**Submission of Further Information (FI)**

**Temporary Shop and Services (Retail Shop for Hardware Groceries and Construction Materials) with Ancillary Facilities for a Period of 5 Years in “Residential (Group D)” Zone, Lots 670 (Part), 671 (Part), 673 (Part), 674, 675, 676, 677 (Part), 679 (Part) and 680(Part) in D.D. 106 and Adjoining Government Land, Yuen Long, New Territories (Application No. A/YL-KTS/1101)**

**Further Information for Planning Application No. A/YL-KTS/1101****Response-to-Comments****Comments from Lands Department**

**Plan 6 (P 22068A)**

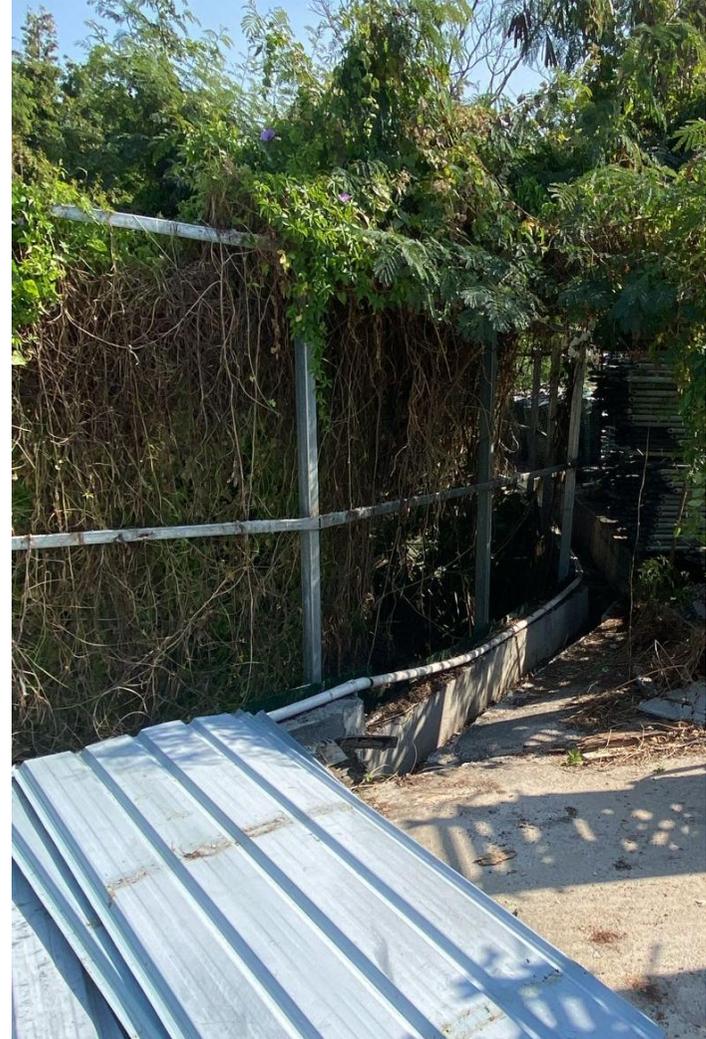
2.	<p>I must point out that the following irregularities covered by the subject planning application have been detected by this office:</p> <p><u>Unlawful occupation of Government land adjoining the said private lots covered by the planning application</u></p> <p>The Government land within the application site (about 845 m<sup>2</sup> as mentioned in the application form) has been fenced off on or after 28.3.2017 without any permission. Any occupation of GL without Government's prior approval is an offence under Cap. 28. LandsD objects to the planning application since there is unlawful occupation of Government Land (GL) and regularization would not be considered according to the prevailing land policy. The lot owner(s) should immediately cease the unlawful occupation of GL as demanded by LandsD. This office reserves the rights to take necessary land control action against the unlawful occupation of Government land without further notice.</p> <p>The lot owner(s)/applicant shall cease the unlawful occupation of Government land and, subject to the approval of the Town Planning Board to the planning application which shall have reflected the rectification as aforesaid required, apply to this office for an STW and/or STT to permit the structure(s) erected and the occupation of the Government land. The application(s) for STW and/or STT will be considered by the Government in its capacity as a landlord and there is no guarantee that they will be approved. The STW and/or STT, if approved, will be subject to such terms and</p>	<p>The fencing within the Government land has been removed. Please refer to the Plan Showing Viewpoints of Site Photographs (<b>Plan 6</b>) and the site photos (<b>Viewpoints 1-4</b>) for details.</p>

Plan 5.2a  
( P 22068A )

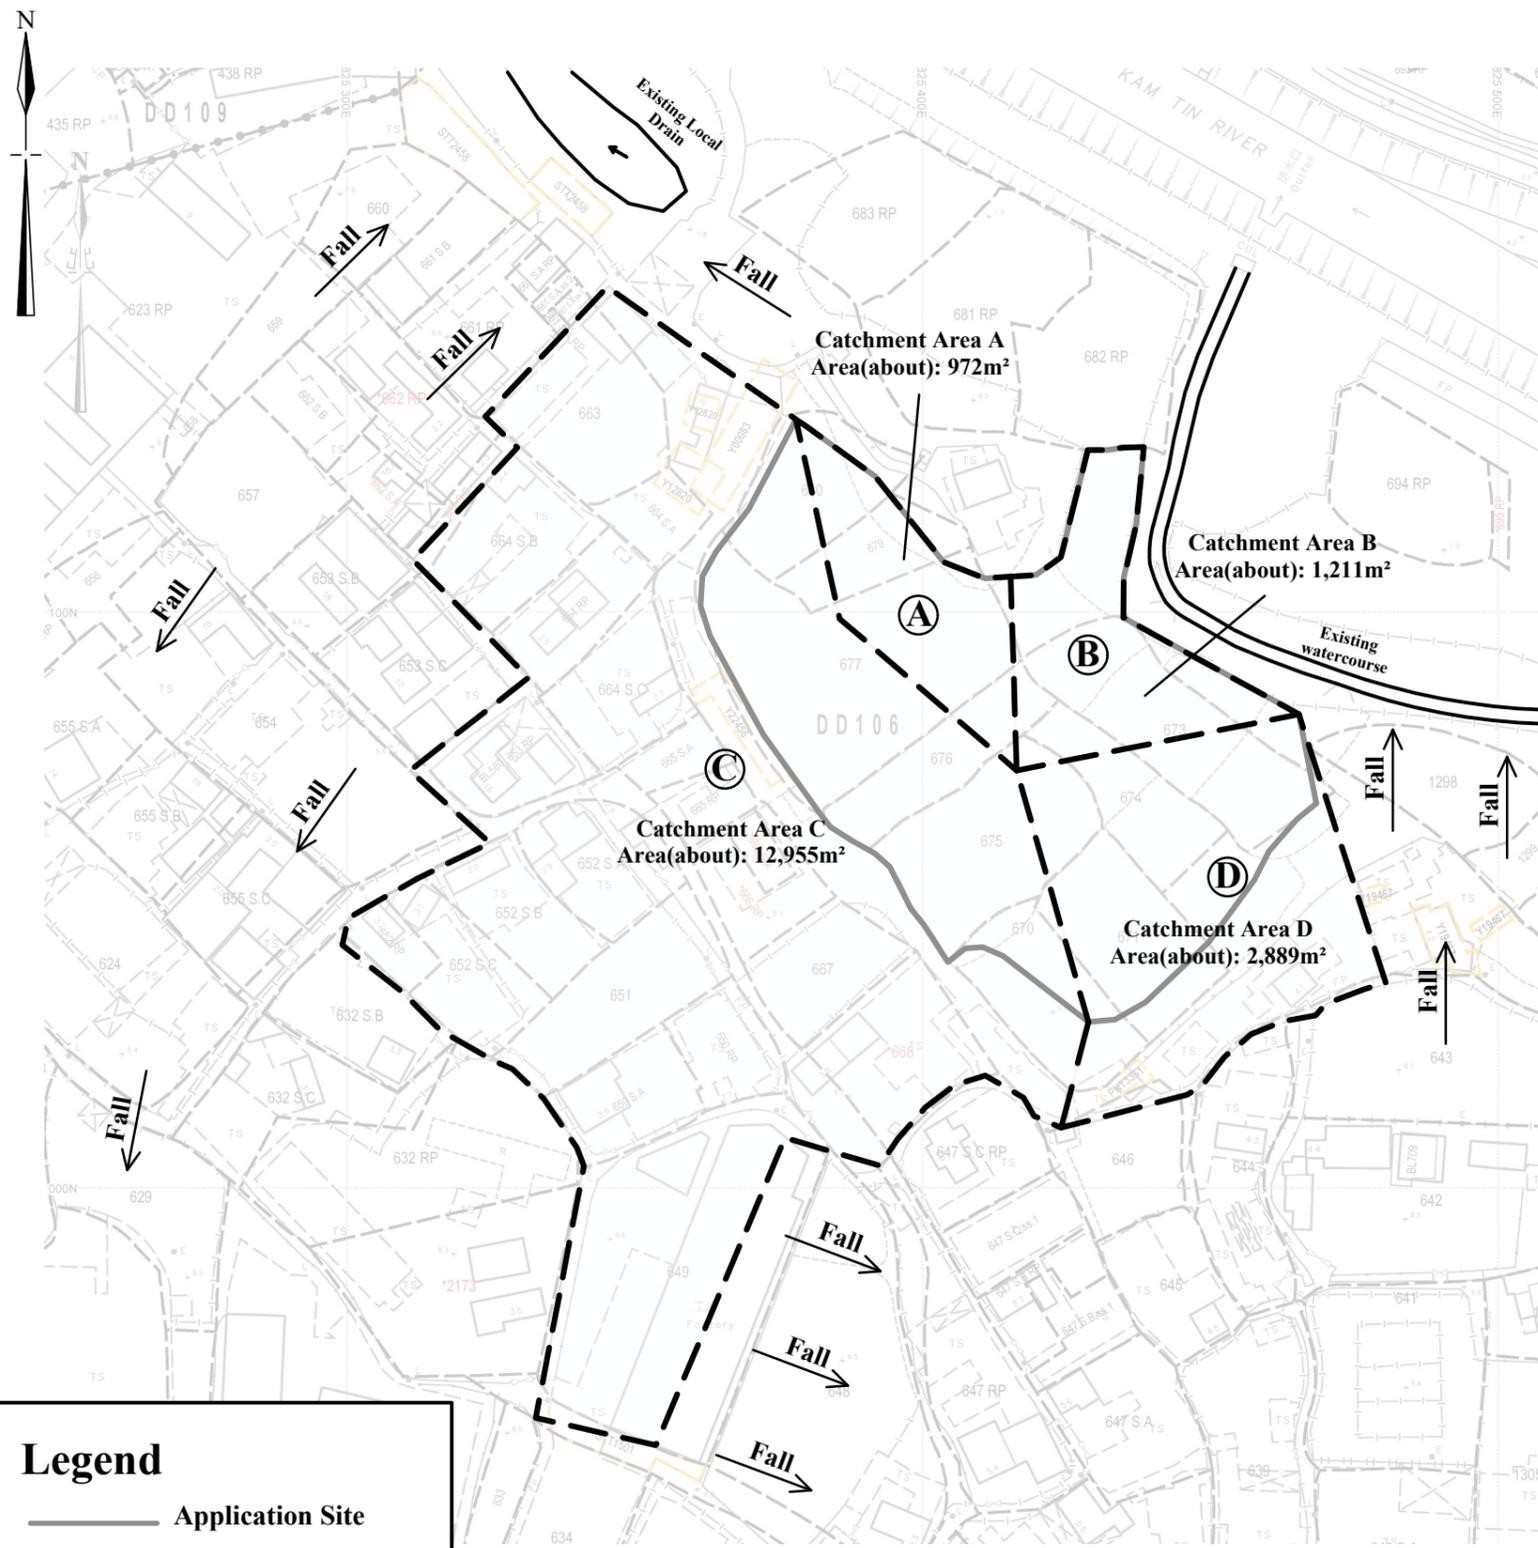
II.	Comments	Responses
1.	The ground to the east, west and south of the application site is significantly higher. Since the overland flow from the adjacent lands shall be probably intercepted, external catchment shall be considered in the calculation. Please make reference to the latest Technical Note No. 1 issued by DSD for more details in preparing the drainage proposal. Please upgrade all proposed and existing drainage facilities size accordingly.	The catchment area is reviewed. Please refer to Plan 5.2a.
